## LETTER REPORT

**SUBJECT:** Review for Proposed Kingsway Sports and Entertainment Complex, City of Greater Sudbury

**DATE:** February 16, 2018

**Figure 2: Estimated Geographic Distribution of Wolves Fans**

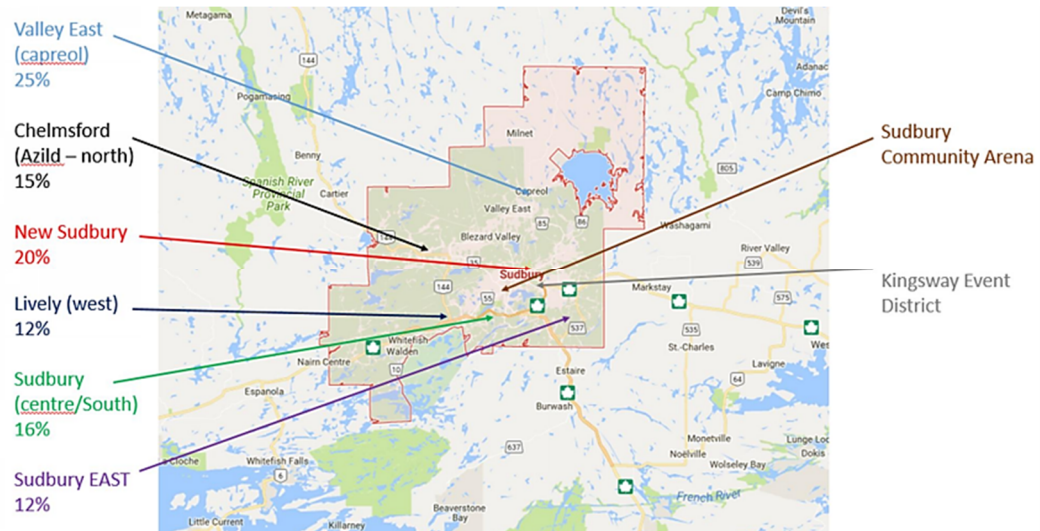
Each proposed land use for the site was given its own trip distribution pattern based on population patterns and the road network. The arena distribution was developed using a distribution of Sudbury Wolves fans around Sudbury. This was provided by Wolves staff and is provided in **Figure 2** below taken from the Consultant's report.
